04 NOVEMBER 2020
PERMIT REVISION

314 WEST 34th STREET
 AUSTIN TX 78705

TWO-FAMILY PROJECT:
 PDU: NEW CONSTRUCTION
 ADU: ADDITION-REMODEL

BOREN ARCHITECTS
 512.554.5474

City of Austin
REVIEWED FOR CODE COMPLIANCE
A0-1

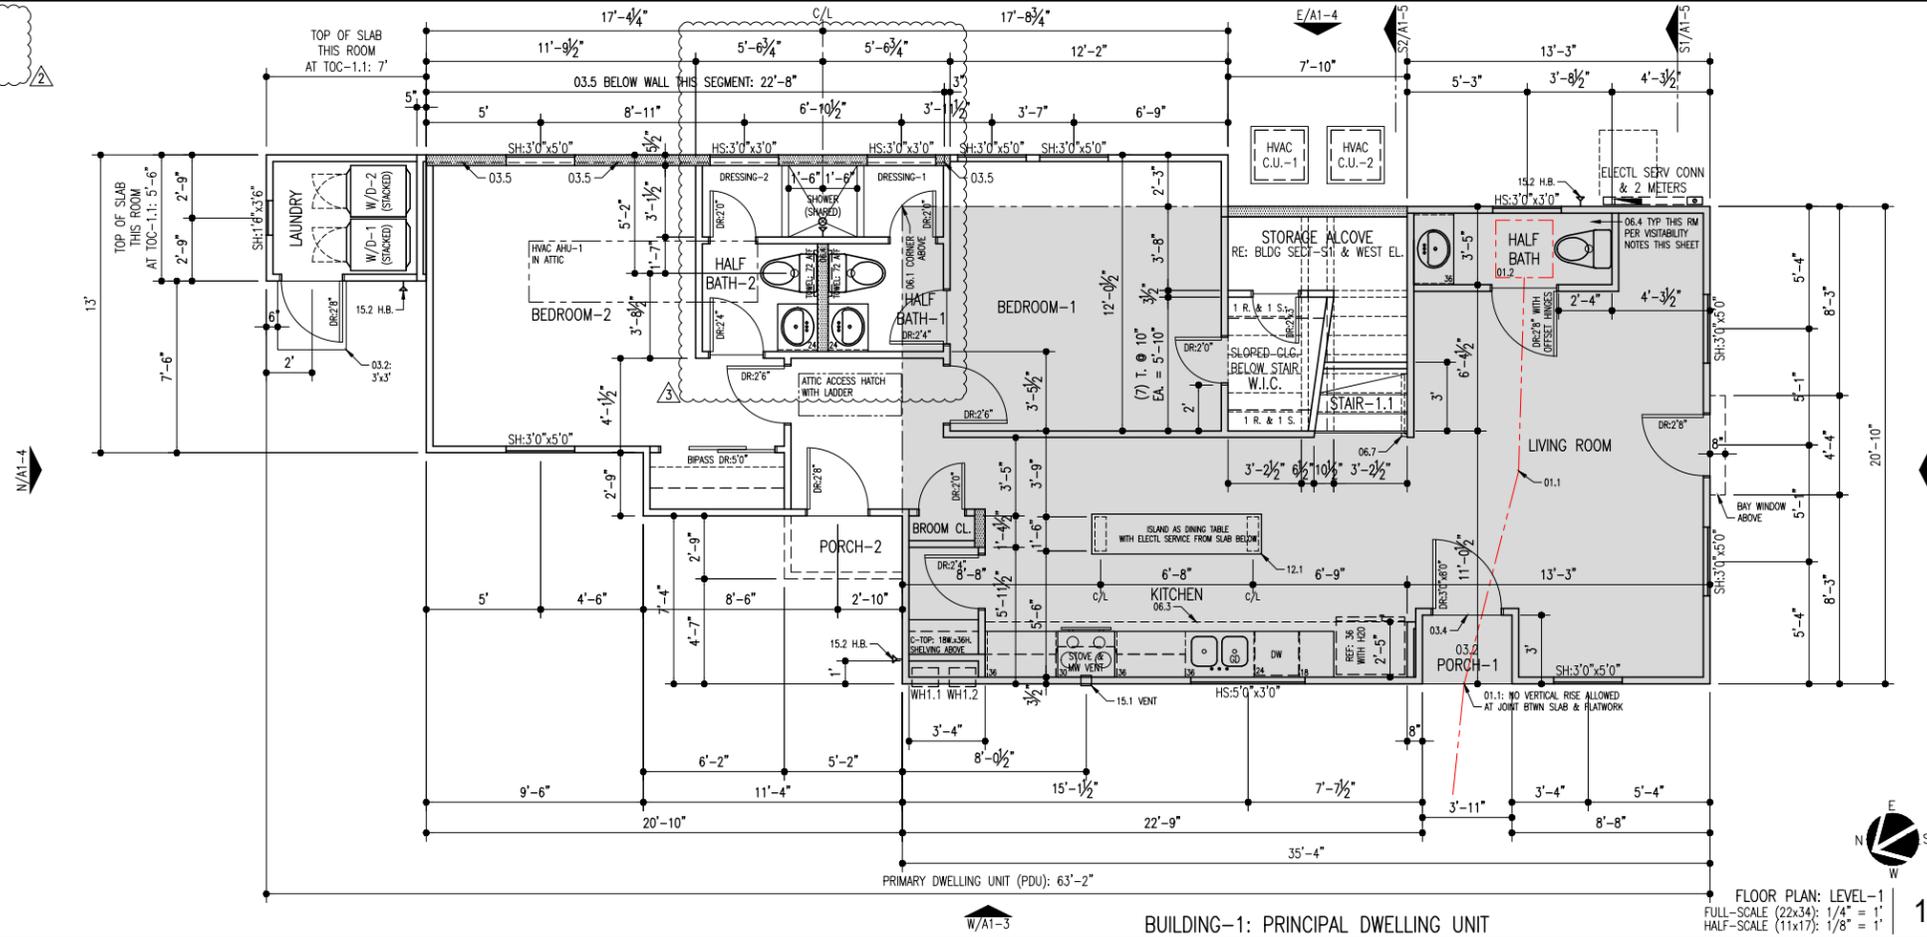
PERMIT REVISION NOTES THIS LEVEL ONLY:
 * DOUBLE, STACKED WASHERS / DRYERS REPLACED WITH SINGLE WASHER / DRYER

DRAWING TITLE:
 BUILDING-1
 FLOOR PLAN-1
 FLOOR PLAN-2

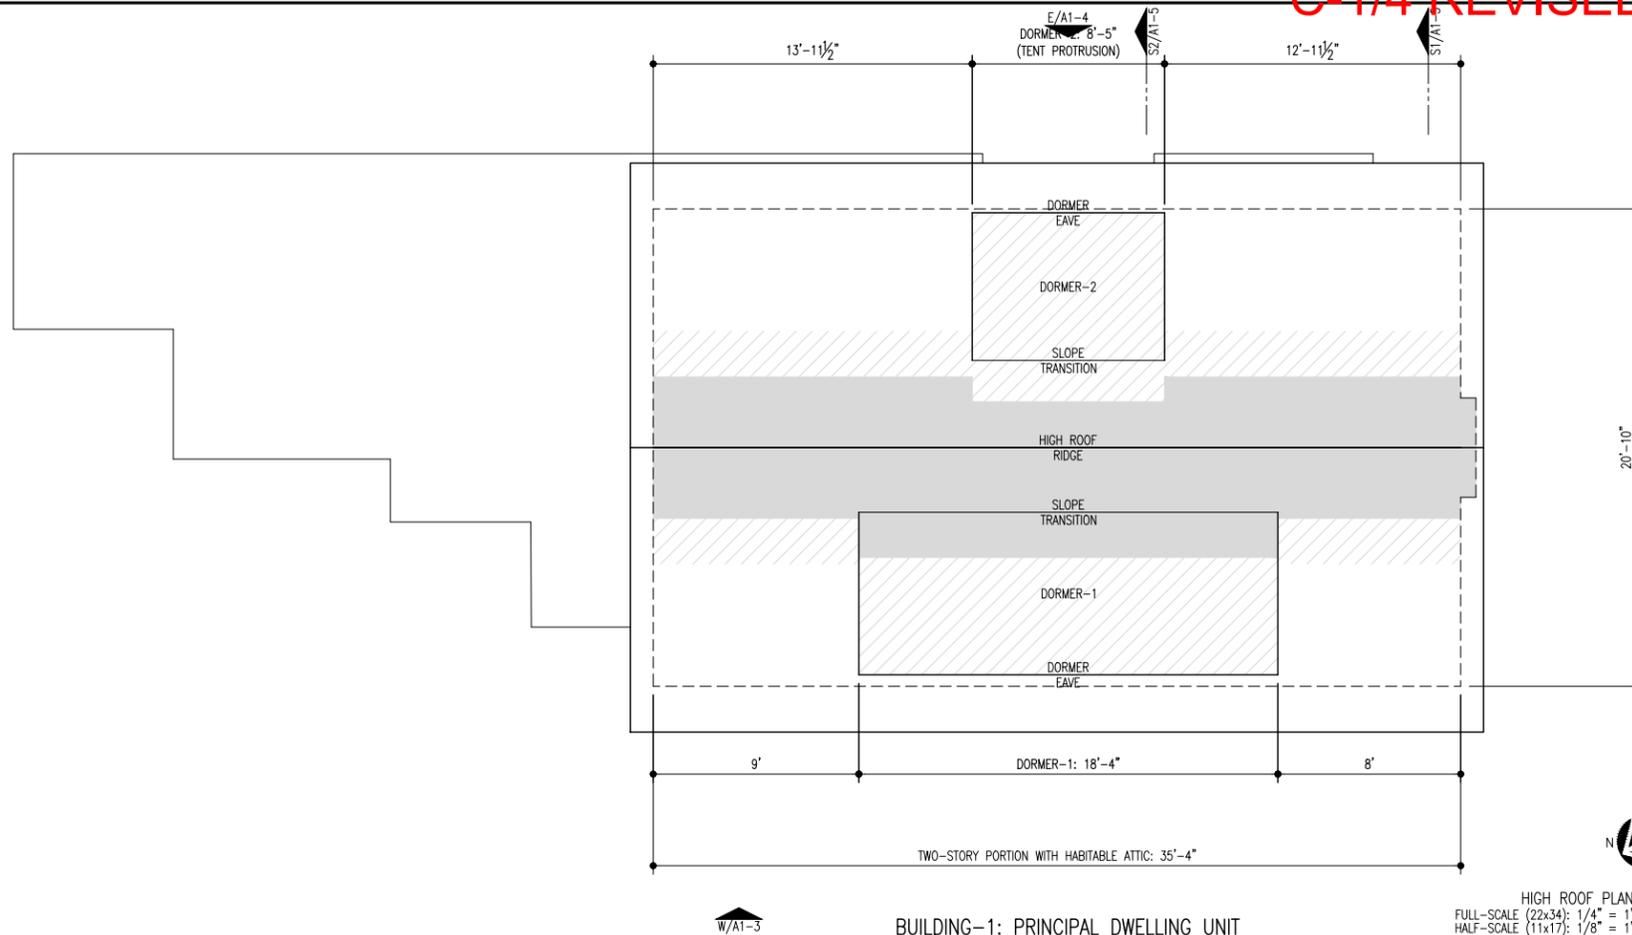
PERMIT REVISION NOTES THIS LEVEL ONLY:
 * SHOWER REMOVED FROM BATH-1 (NO LONGER A FULL-BATH BUT A HALF-BATH) AND REPLACED WITH A CLOTHES WASHER & DRYER

DRAWING TITLE:
BUILDING-1
FLOOR PLAN-3
HIGH ROOF PLAN

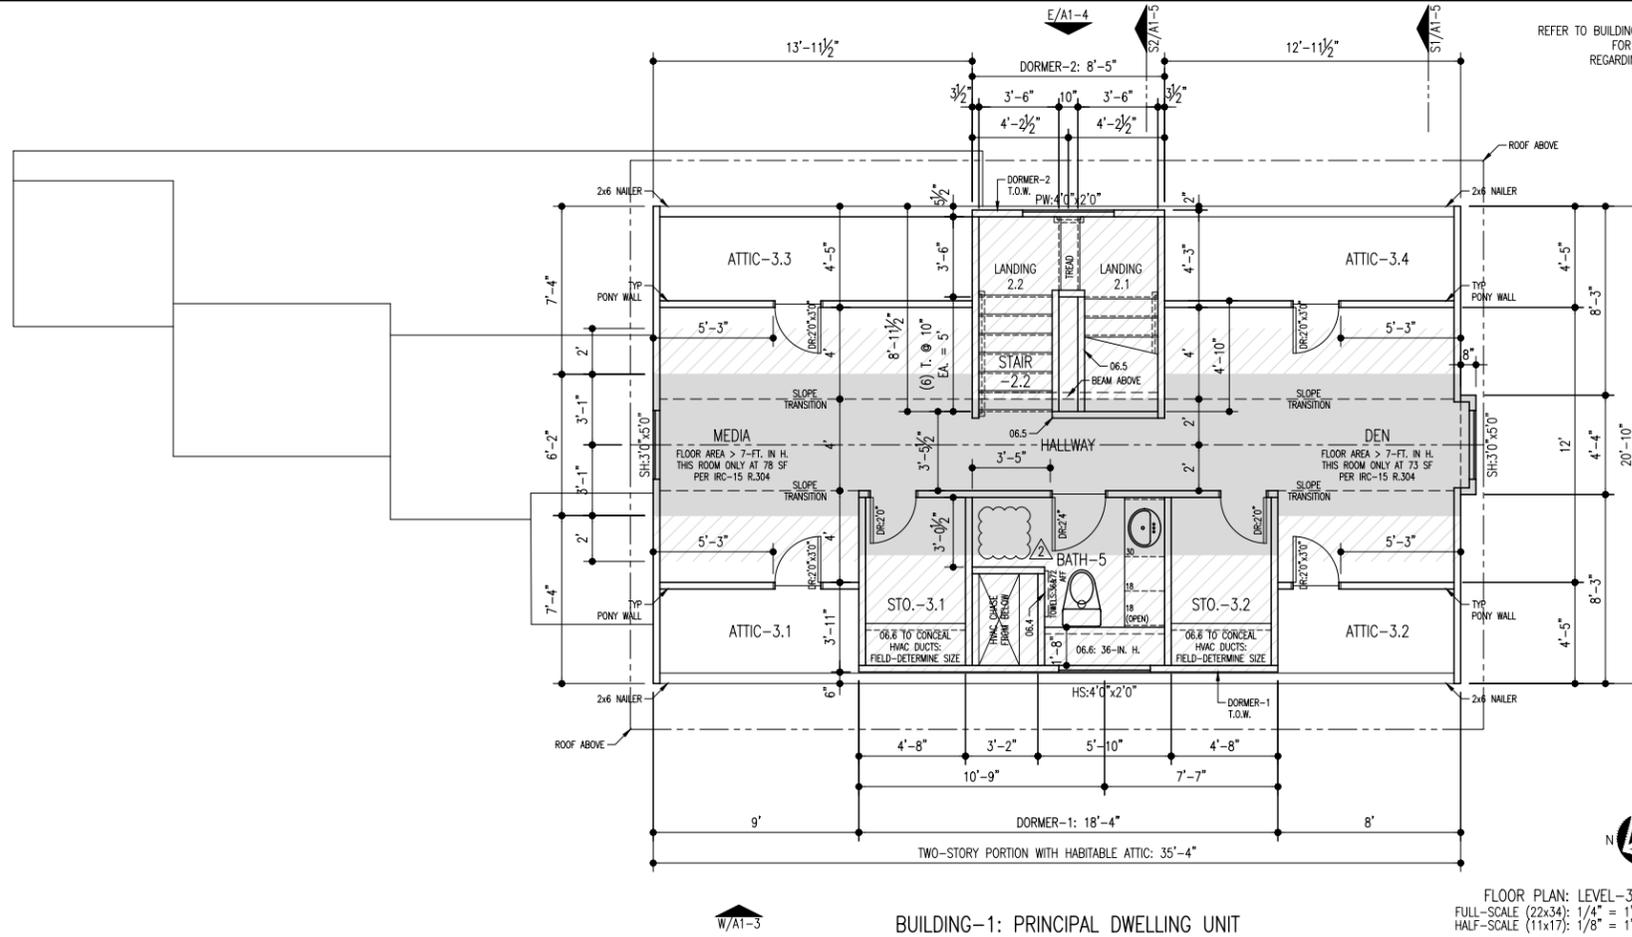
PERMIT REVISION NOTES THIS LEVEL ONLY:
* SHOWER REMOVED FROM BATH-5
(NO LONGER A FULL-BATH BUT A HALF-BATH)

DRAWING TITLE:	BUILDING-2 (ADU) (EXISTING / REMODEL) ELECTRICAL & ROOF PLANS
DATE:	AS NOTED
PROJECT:	1910: 314
SCALE:	AS NOTED
DRAWN:	DPB
SHEET:	314

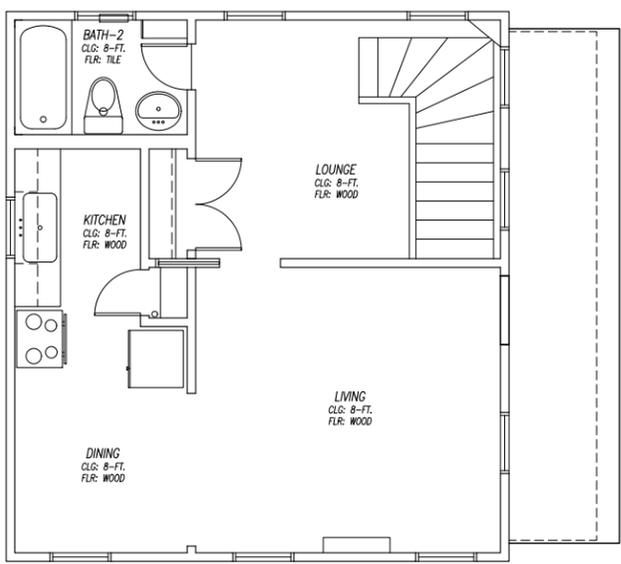
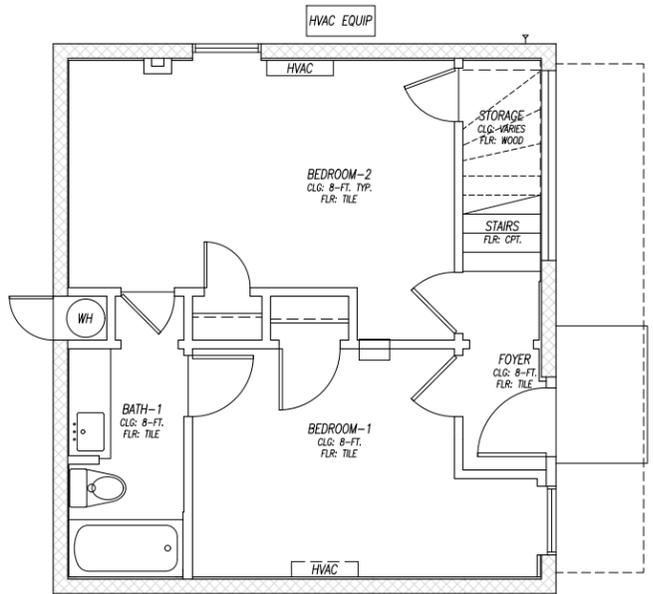
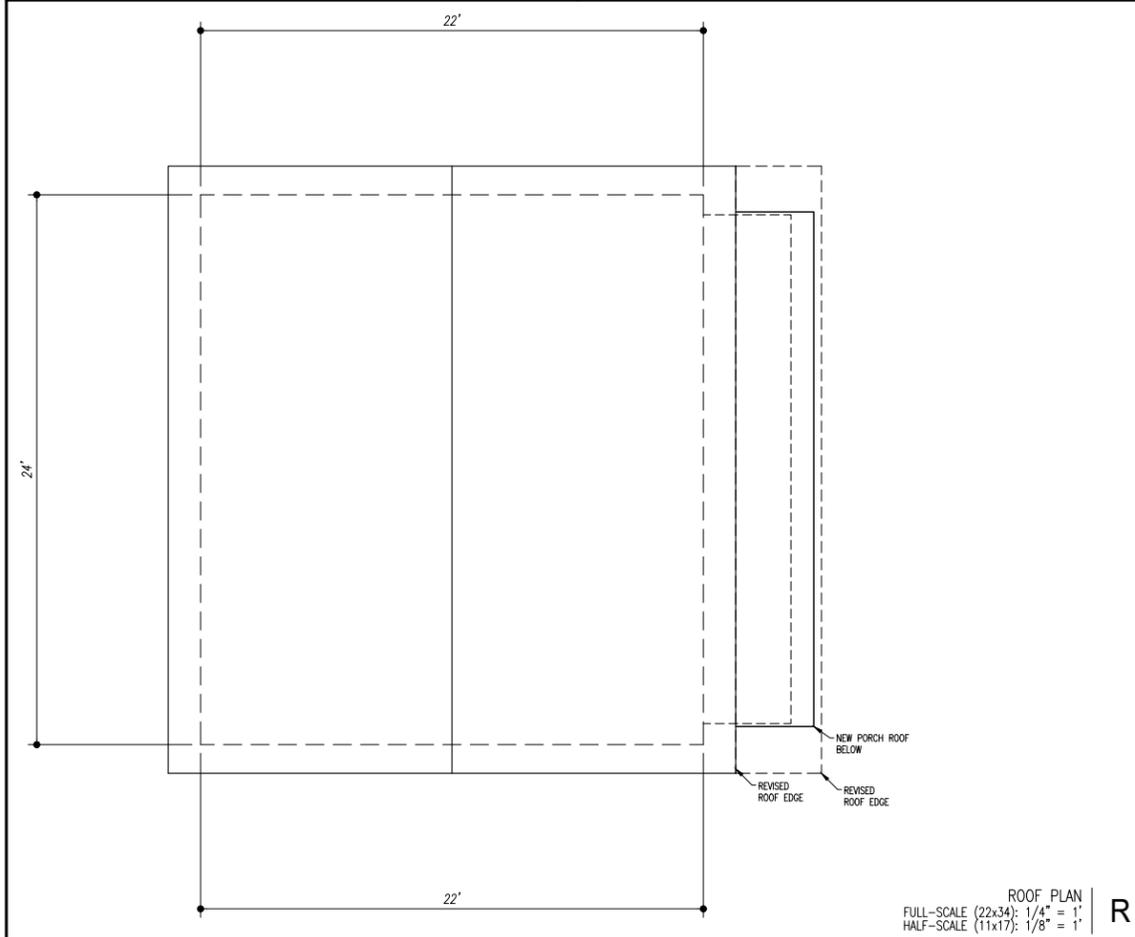
PERMIT REVISION NOTES - ELECTRICAL ONLY:
ELECTRICAL WORK HAS BEEN DELETED FROM SCOPE-OF-WORK EXCEPT WORK FIELD-DETERMINED BY A LICENSED ELECTRICIAN AND/OR CITY OF AUSTIN INSPECTOR TO BE REQUIRED

PERMIT REVISION NOTES - ELECTRICAL ONLY:
ELECTRICAL WORK HAS BEEN DELETED FROM SCOPE-OF-WORK EXCEPT WORK FIELD-DETERMINED BY A LICENSED ELECTRICIAN AND/OR CITY OF AUSTIN INSPECTOR TO BE REQUIRED
